Affected Products – RSE/RSOE series

Dear customers and distributors, we herewith inform you about Product Change Notice* concerning the following products:

RSE, RSOE series (all versions).

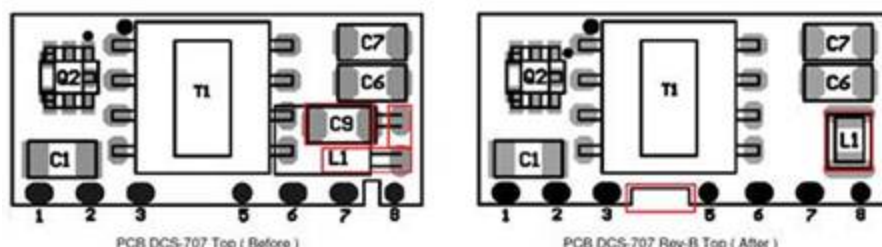
The electronics industry is moving to smaller-sized passive components and discontinuing the larger size formats. For example, 1206 resistor dimensions are migrating to 0805. It is therefore necessary to change the internal PCB layout of these products to accommodate the smaller standardized sizes.

We have also taken the opportunity to rearrange some the components on the PCB now we have more room and, in particular, to switch from through-hole to SMD-mount inductors. This is to improve the production yield and performance stability by increasing the automation grade of the converters.

The new PCB layout is identified by a notch between pins 3 and 5 so that it can be more easily identified by x-ray inspection after assembly.

Series	Component (before)	Component (after)
RSE and RSOE	PCB code: DCS-707	PCB code: DCS-707 rev.B
